SUBJECT: Coastside Design Review
Avenue Alhambra, El Granada
APN 047-043-240; County File No. PLN 2016-00085

At its meeting of December 8, 2016, the San Mateo County Coastside Design Review Committee (CDRC) considered your application for a design review permit to allow construction of a new 3,067 sq. ft. two-story single-family residence (including a 587 sq. ft. attached two-car garage) on a 6,485 sq. ft. legal parcel (Certificate of Compliance recorded on November 12, 2015). The project involves minor grading and no tree removal.

X1 REAR ELEVATION VIEW-EAST LOOKING WEST

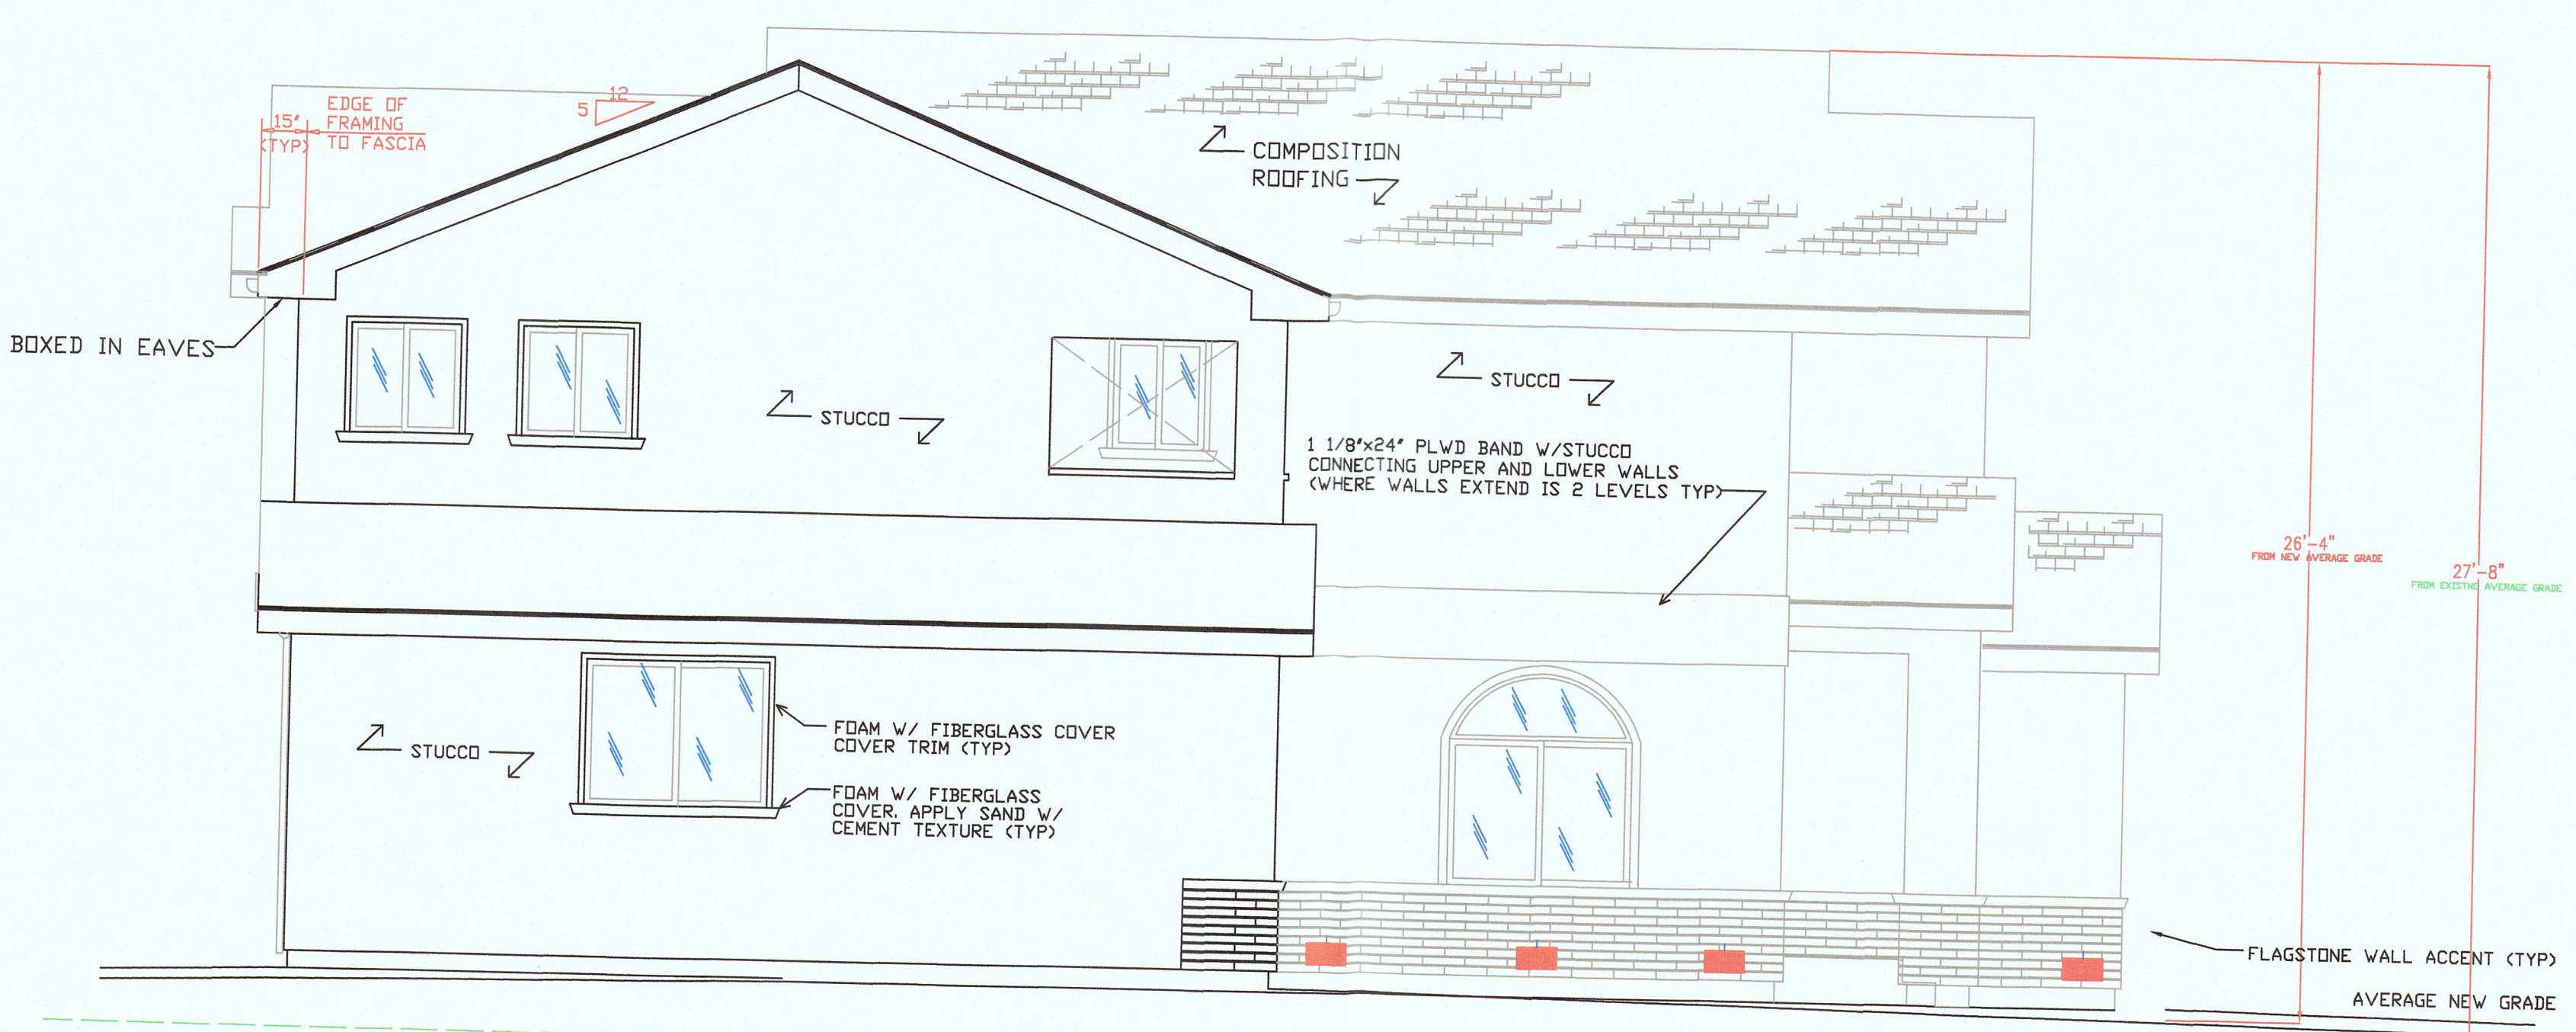
- a. *Section 6565.20(D). ELEMENTS OF DESIGN; 1. Building Mass, Shape and Scale; e. Wall Articulation. Standard (2).* Provide projecting or recessing architectural details and changes in building materials or colors to visually break up building walls in the Rear/East and Side/South elevations. This standard also needs to be applied to the enclosed decks in the project design to reduce their apparent mass.

FRONT ELEVATION VIEW-WEST LOOKING EAST
1/4"=1'-0"

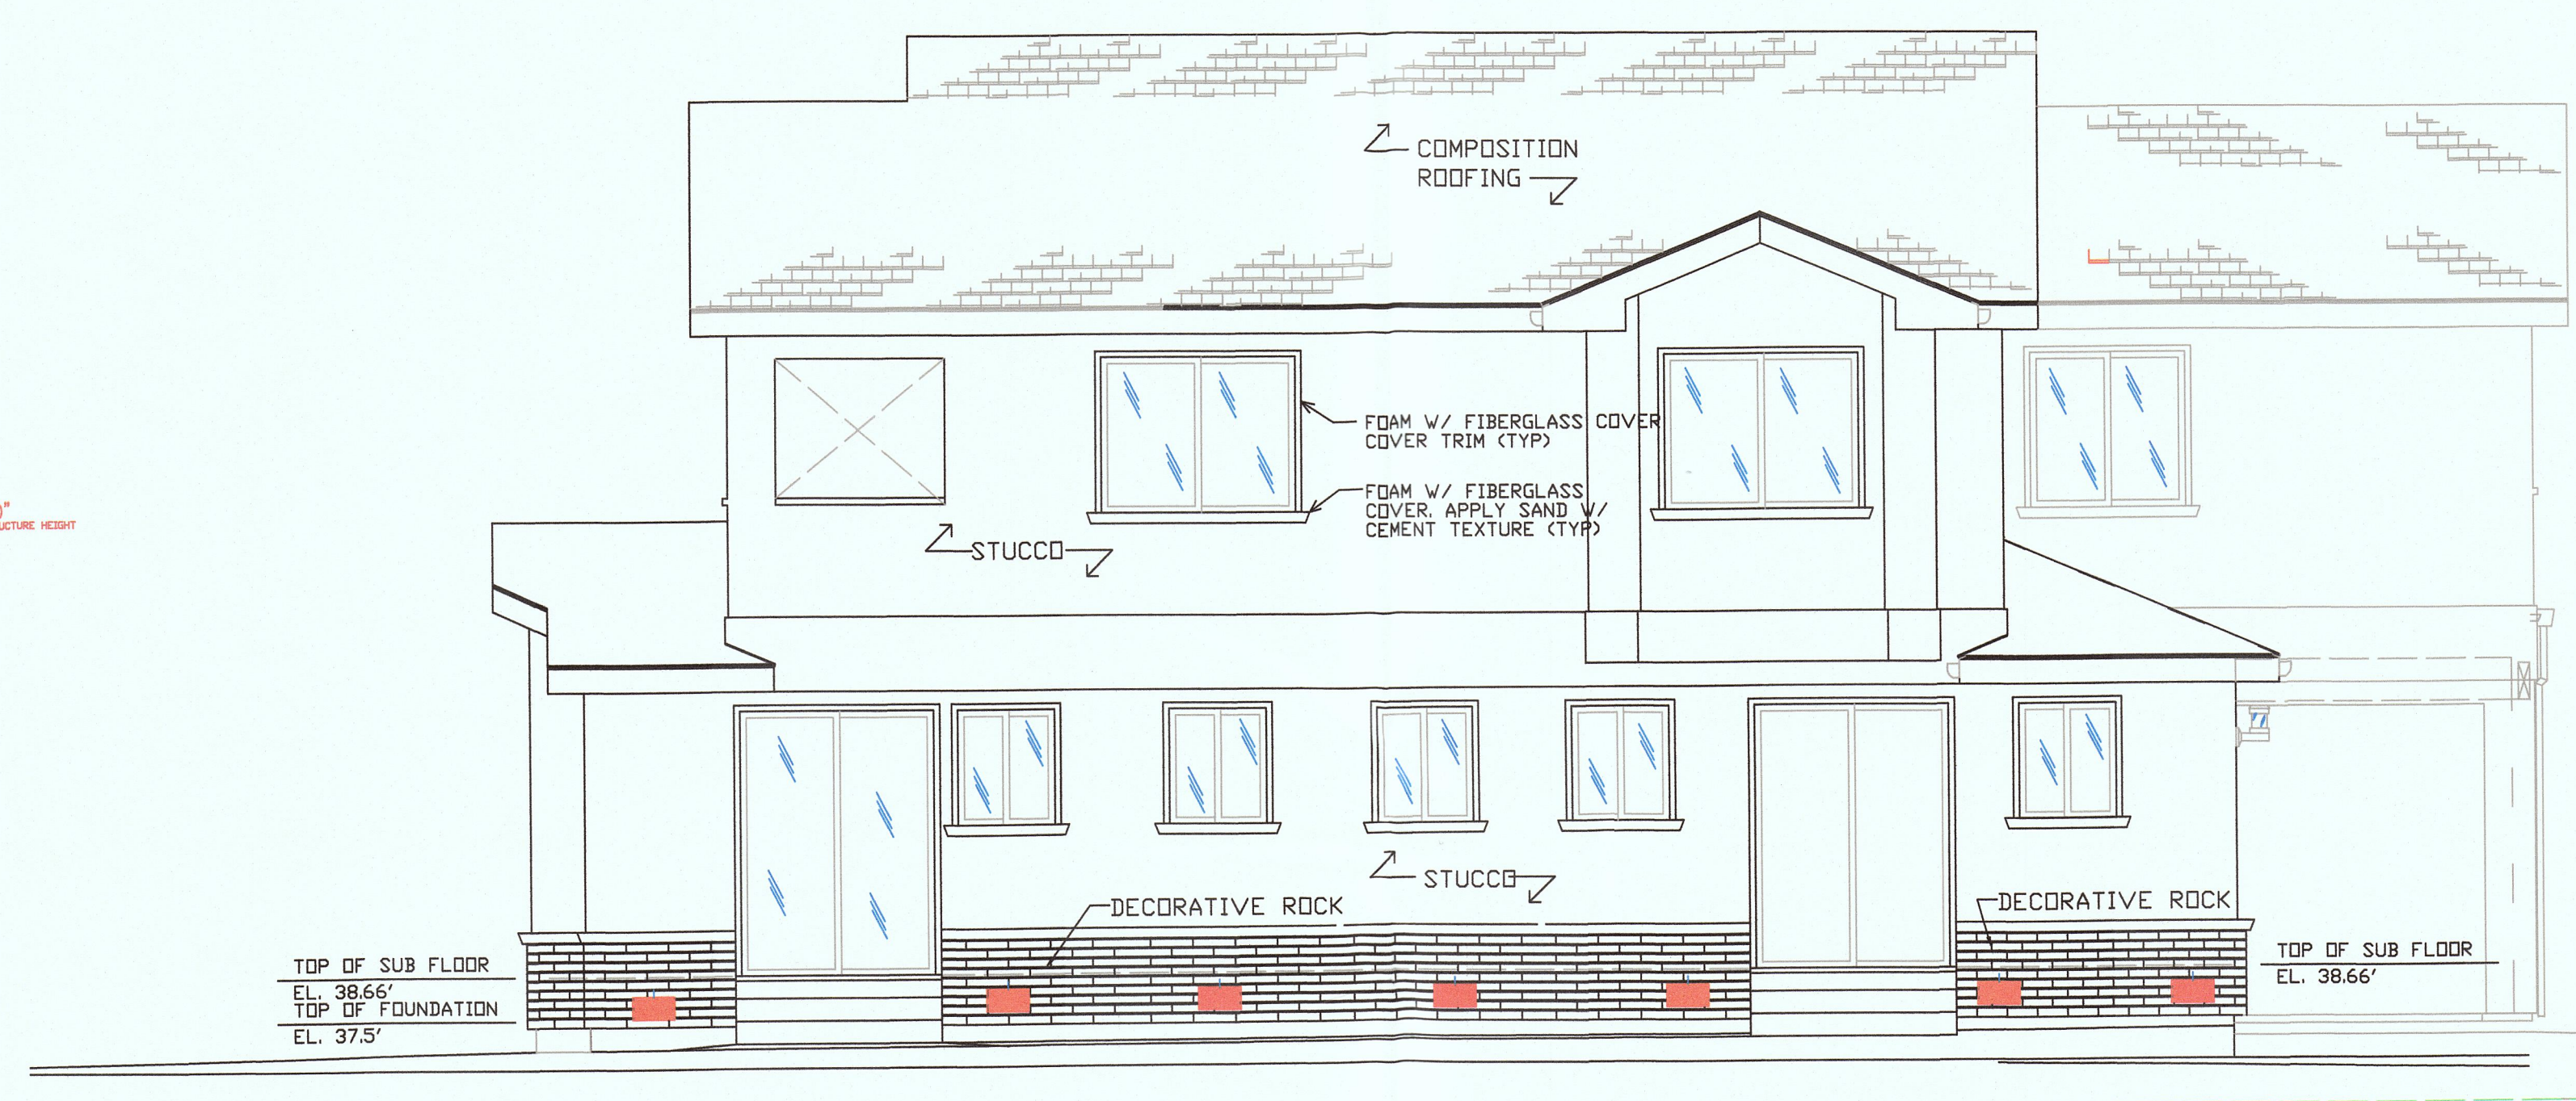
- b. *Section 6565.20(D). ELEMENTS OF DESIGN; 2. Architectural Styles and Features; b. Openings. Standard (1).* Select windows for the Front elevation that are compatible with the other windows and features of the house (See the picture on page 15 of "Standards for Design for One-Family and Two-Family Residential Development in the Midcoast" manual).

- c. *Section 6565.20(D). ELEMENTS OF DESIGN; 2. Architectural Styles and Features; c. Entries. Standards (1) and (2).* Design the front entry to be on a scale compatible with other features of the house (1) and so that it is similar in size and proportion to other homes in the neighborhood (2) (See the picture on page 16 of "Standards for Design for One-Family and Two-Family Residential Development in the Midcoast" manual).

LANDSCAPING AND IRRIGATION PLAN

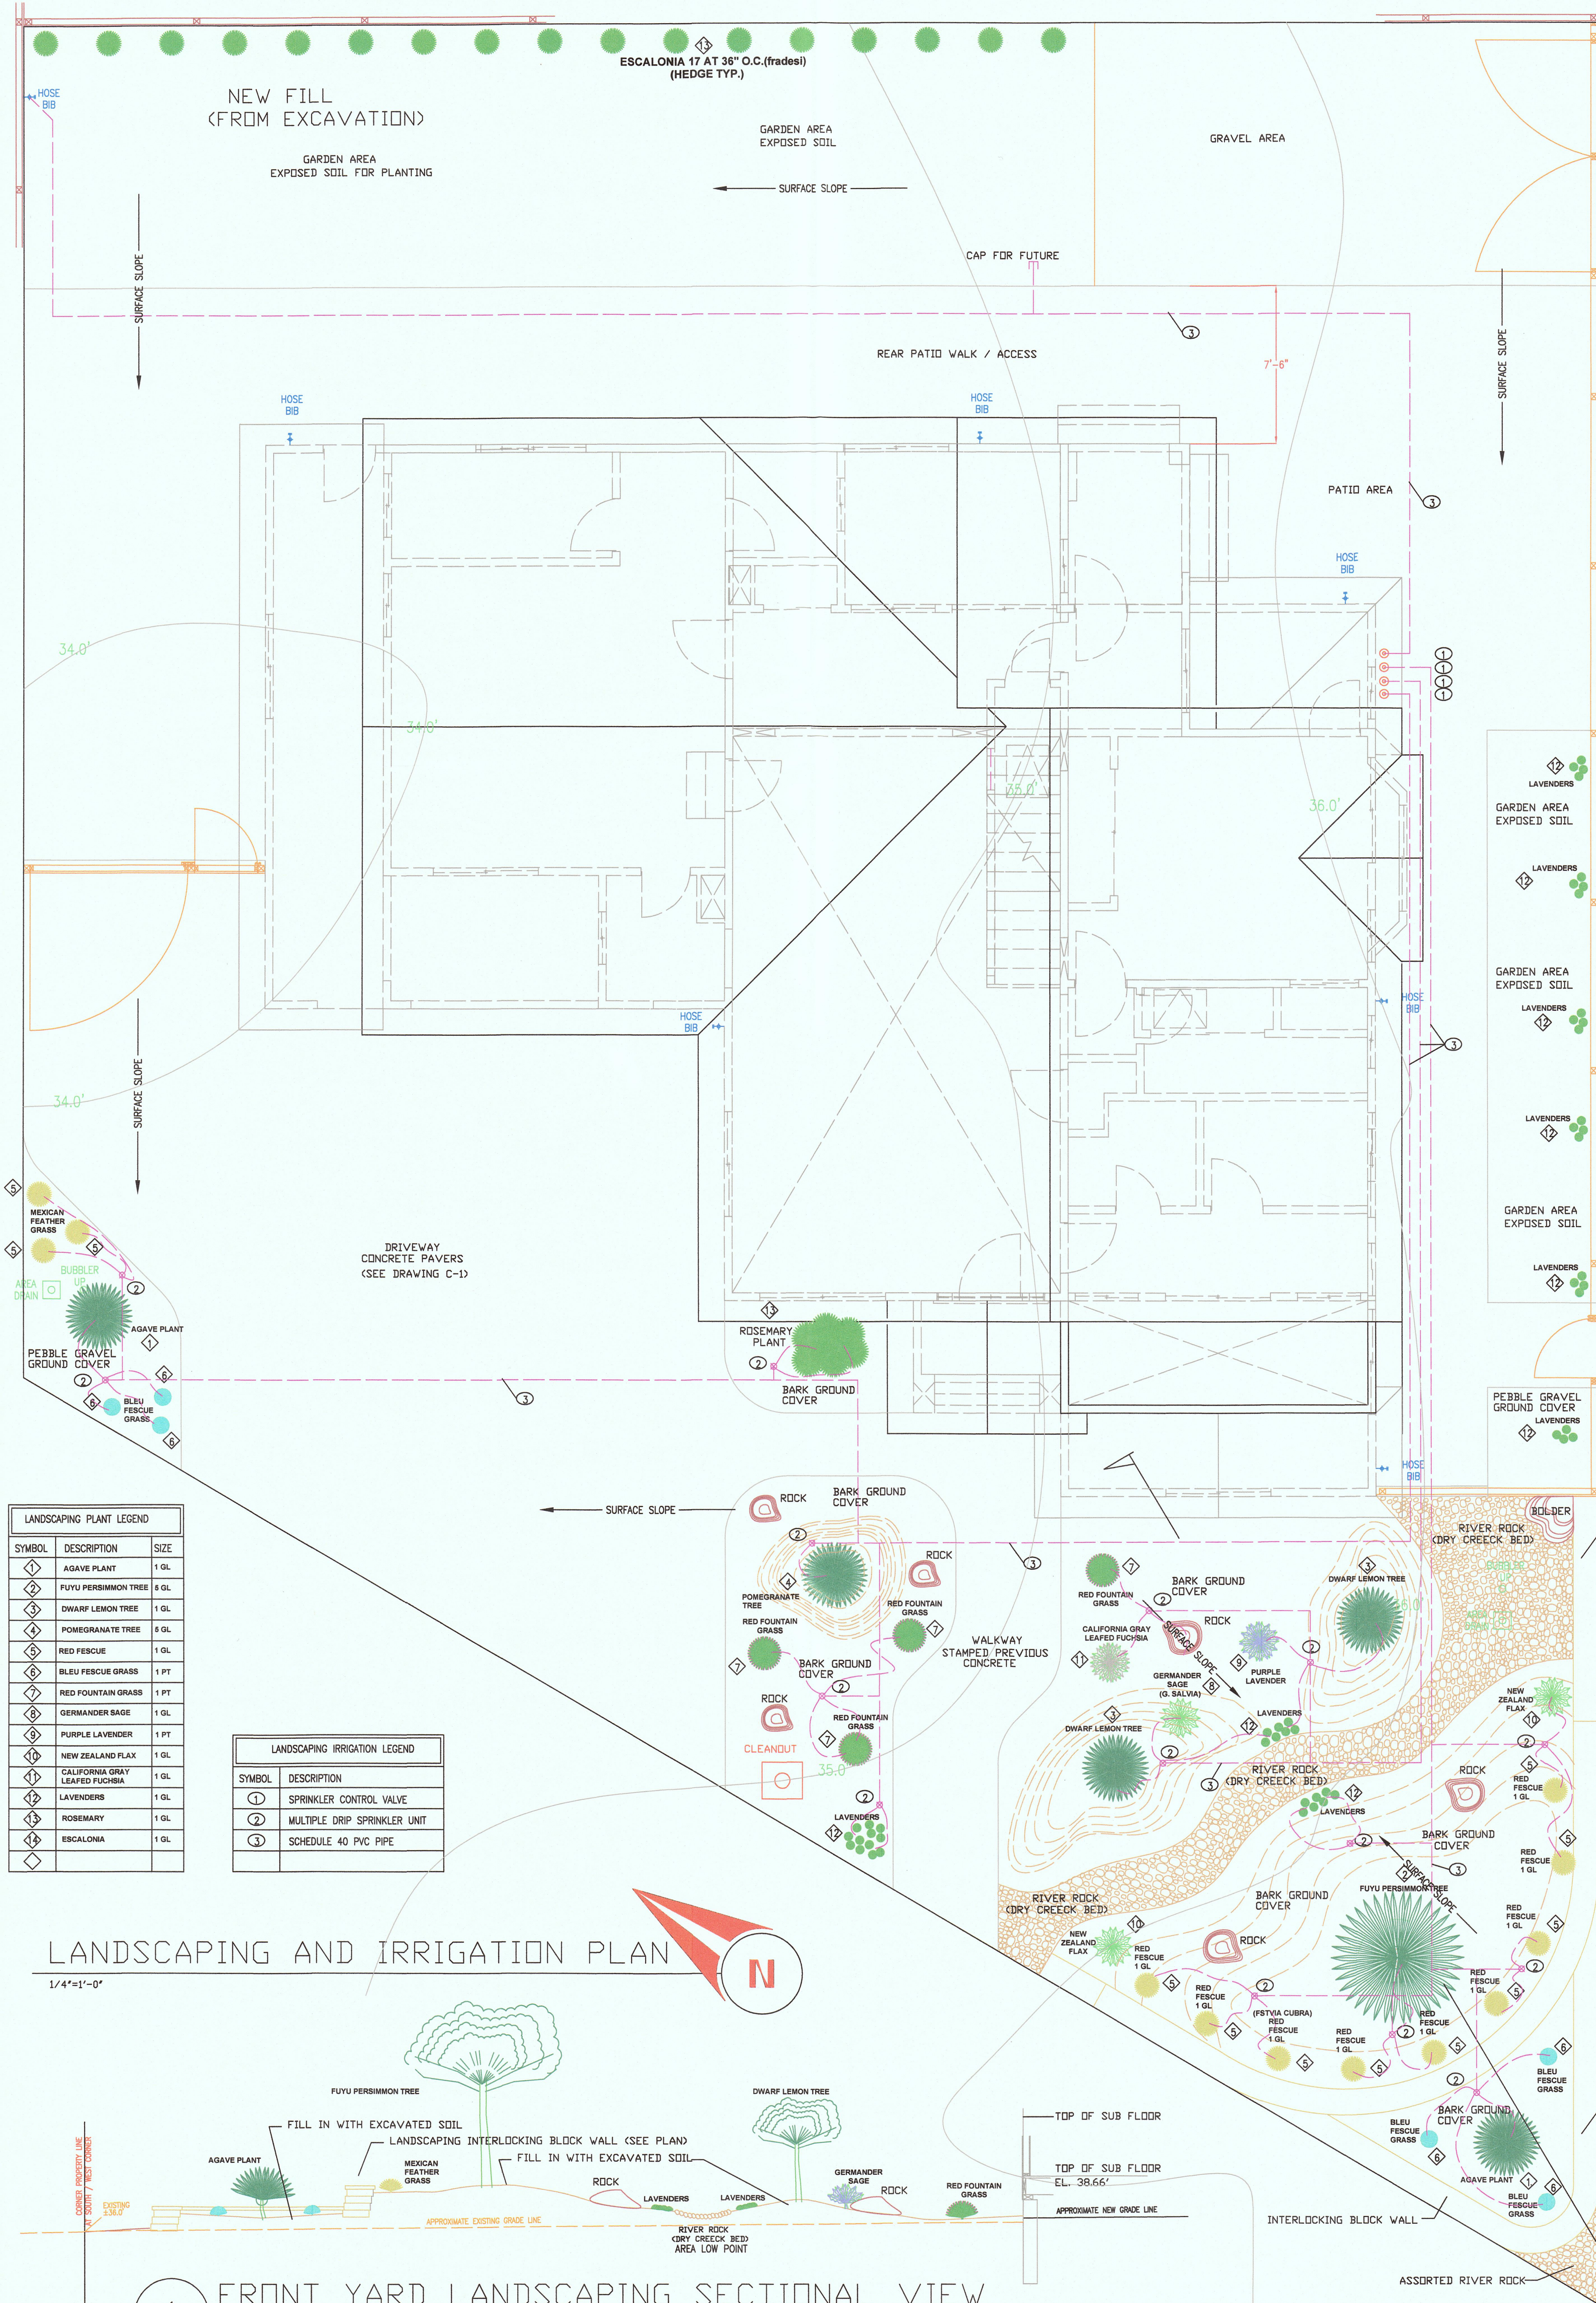
- d. *Section 6565.20(F). LANDSCAPING, PAVED AREAS, FENCES, LIGHTING AND NOISE; 1. Landscaping; Standards (b) and (f).* Further develop the landscape plan to provide for additional landscaping throughout the property to enhance the design of the house and complement the vegetation in the surrounding neighborhood (b); and use only drought-tolerant and either native or non-invasive plant species (f). Specifically, remove the Mexican Feather Grass from the landscape plan, and specify the size of the plantings indicated in the landscape plan.

- e. *Section 6565.20(F). LANDSCAPING, PAVED AREAS, FENCES, LIGHTING AND NOISE; 2. Paved Areas; Standards (a) and (c).* Minimize and revise the hardscape areas to provide a more natural appearance and to reduce the volume and improve the quality of runoff into creeks and storm drains (a); and redesign driveways, walkways, and parking areas on-site to be as small as possible within allowable standards.
